TOWN OF SEWALL'S POINT, FLORIDA

SHEET 1 OF 8

NICHOLAS SMITH
 133 SO RIVER ROAD
 SEWALL'S POINT

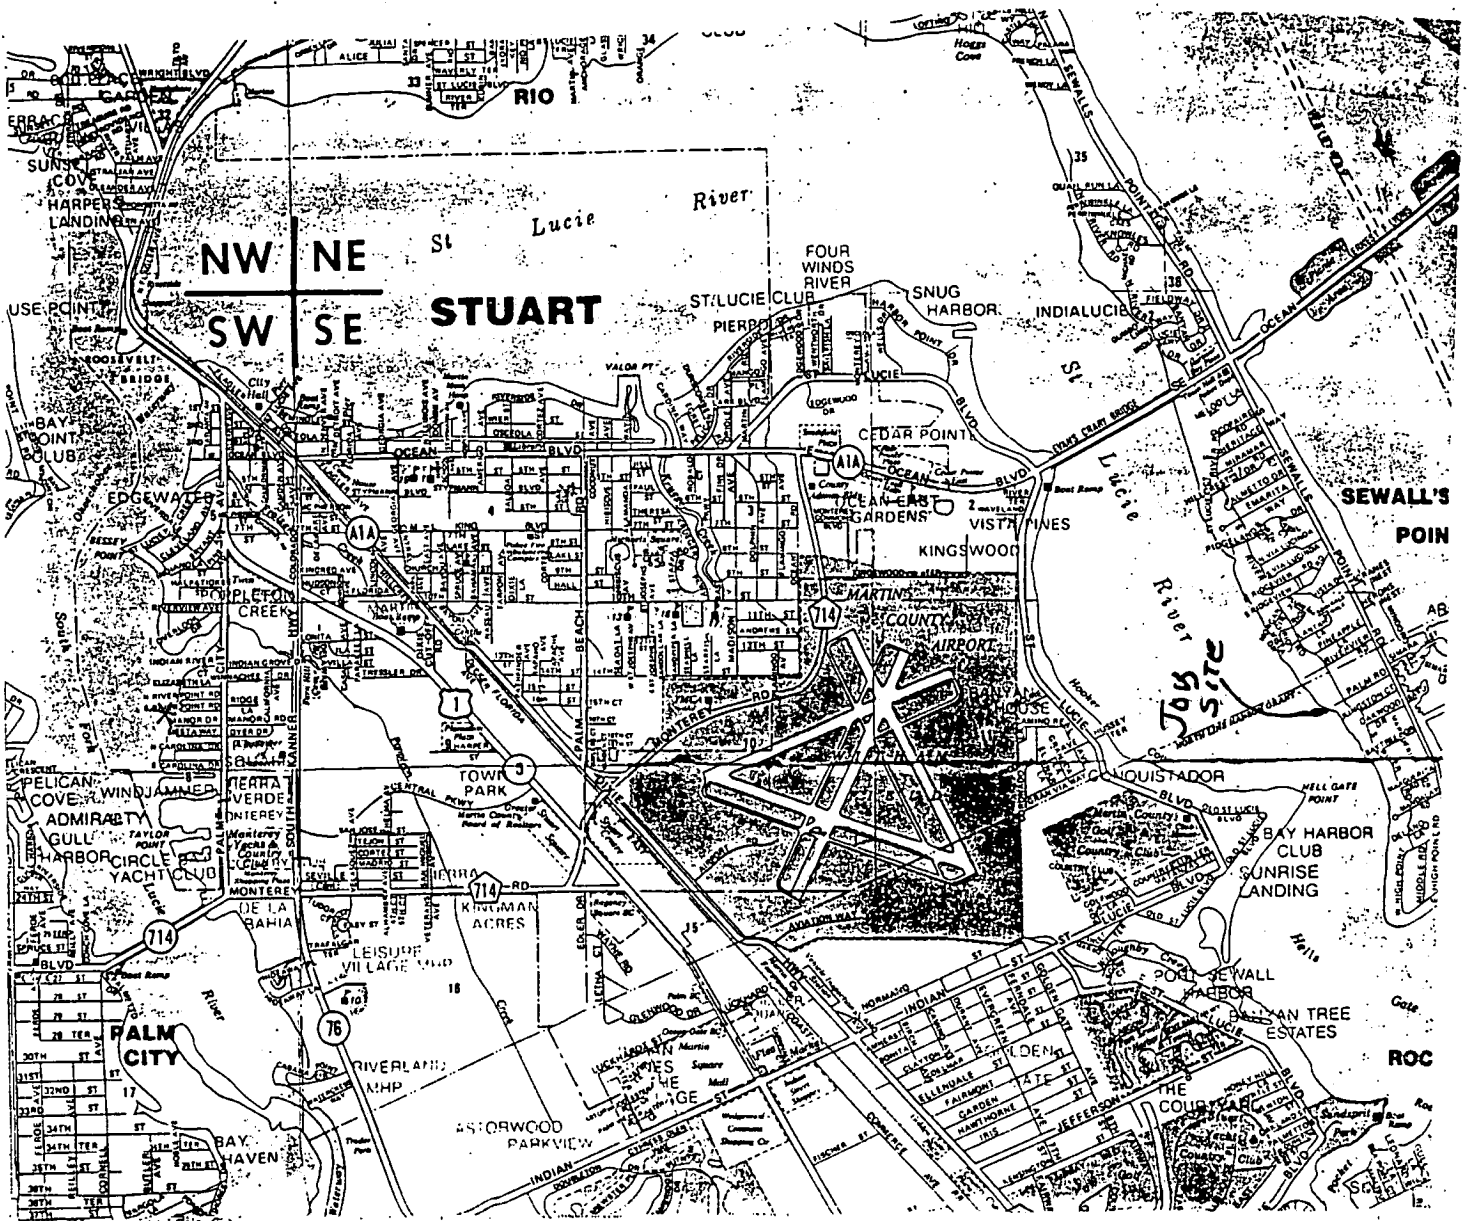
- NOT TO EXCEED 15' ABOVE PLATFORM
- TOP OF ROOF SHALL NOT EXCEED FINISHED GRADE OF THE UPLAND RIPARIAN PROPERTY TO WHICH THE DOCK IS APPURTENANT

NOTE 1. REVISE & RESUBMIT W/ AREA UNDER ROOF IN COMPLIANCE W/ ORDINANCE (§ 4.5-6(2))

NOTE 2. TOPOGRAPHICAL SURVEY & ADDITIONAL DIMENSIONAL INFORMATION REQUIRED (SHEET 7)

NOTE 3. PROVIDE COPY OF LICENSE & CURRENT CERTIFICATES OF INSURANCE (LIAB & WC) W/ TOWN OF SEWALL'S POINT AS CERTIFICATE HOLDER PRIOR TO PERMIT ISSUANCE

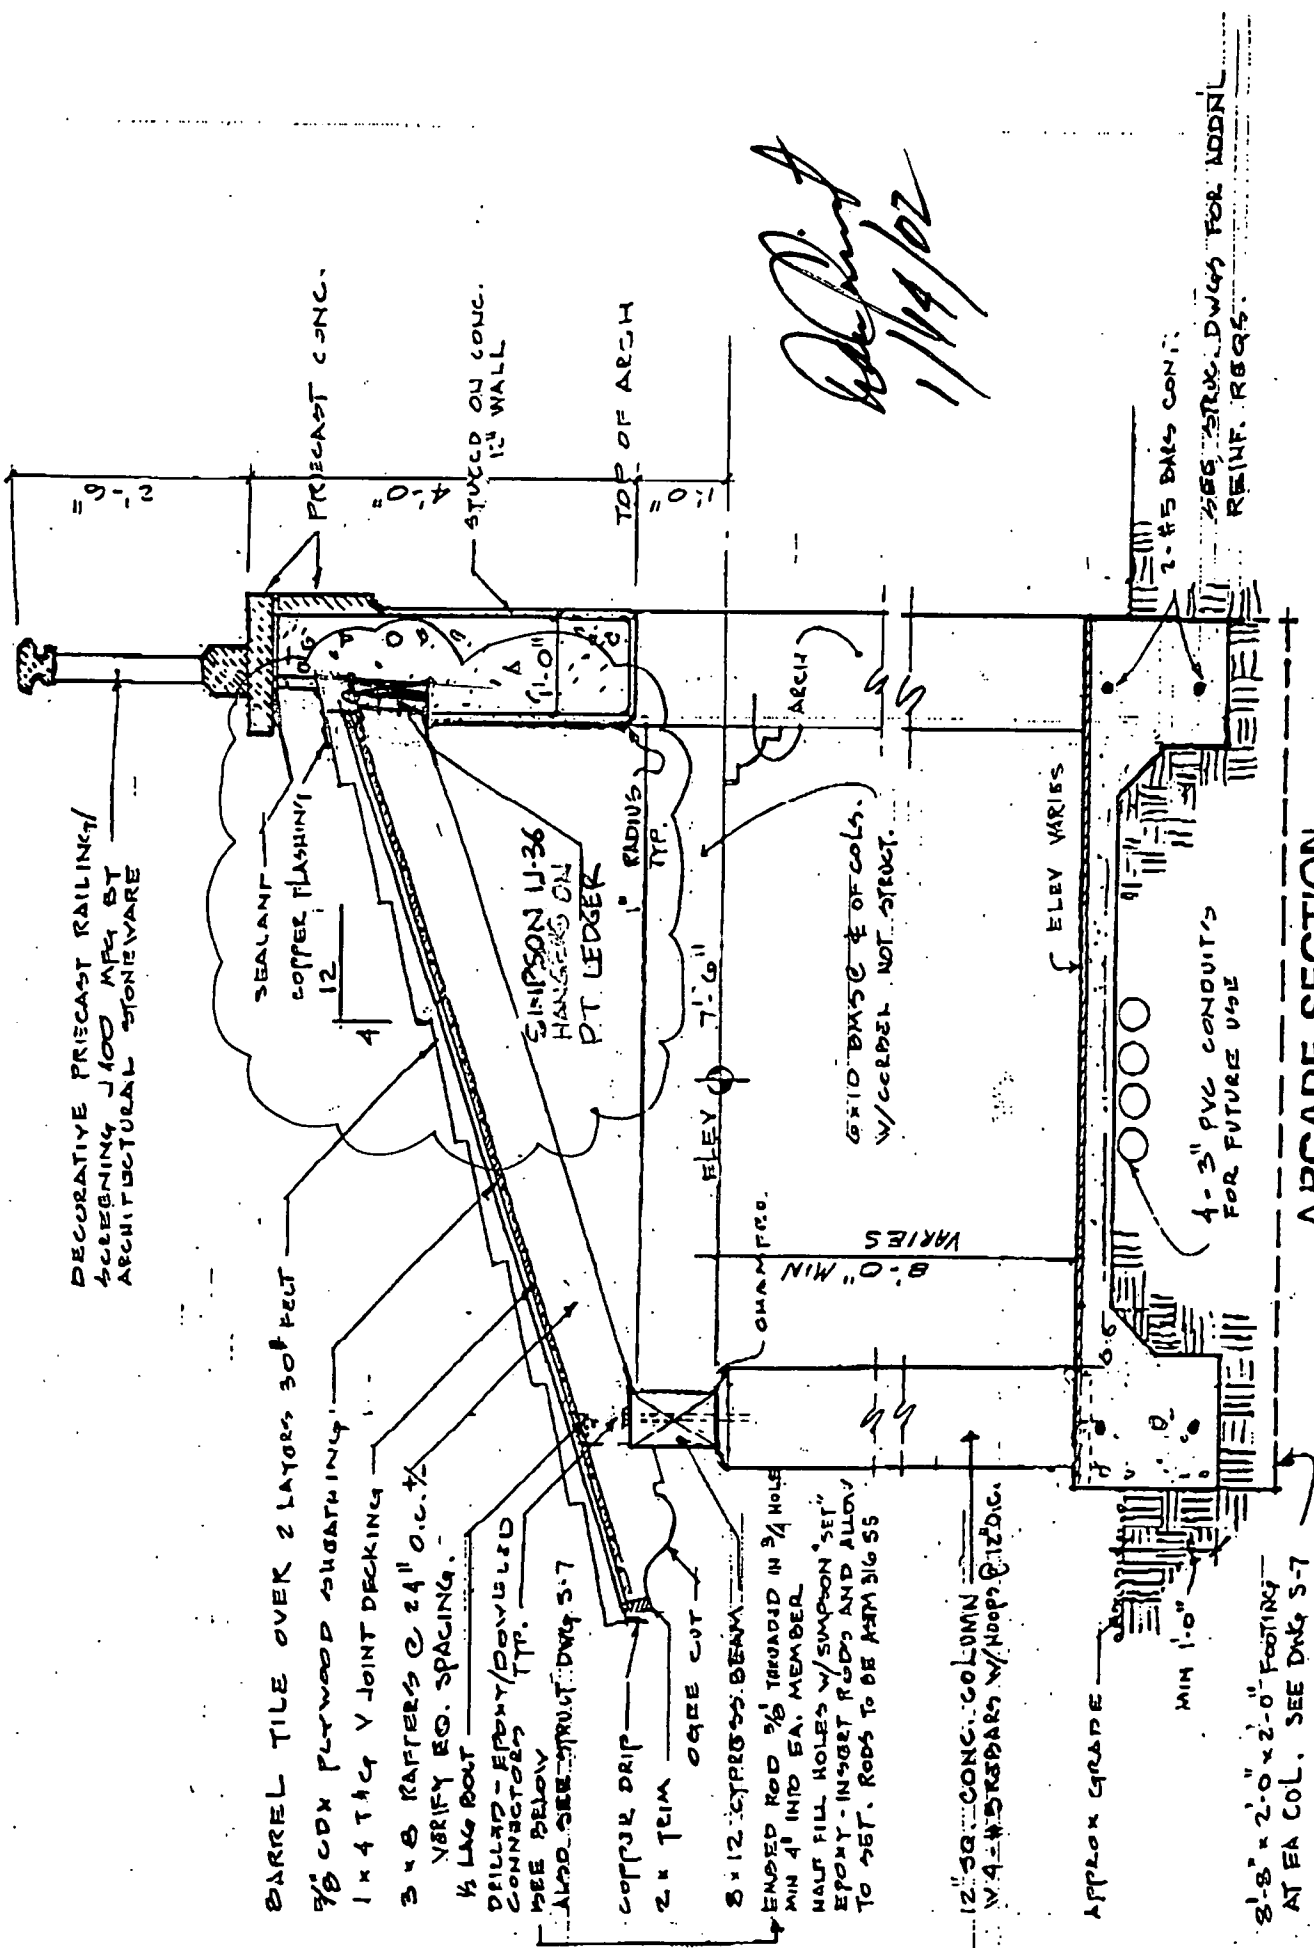
1. Lintels L23, L13, L22, L12, L21, & L11, These are to be replaced with poured concrete beams with a minimum dimension of 8" x 12" Ea. and Shall have 2-#5 bars at top & bottom.
2. Tie beam TB-2 in the garage is to be extended. This is to be cantilevered 2' over to the south, in two locations, extending behind the rake beams on the east and west ends.
3. With reference to the Colonnade roof beams, beam pockets are to be provided for the wood roof beams as shown on the enclosed dwg. And in detail # D on sheet A7.
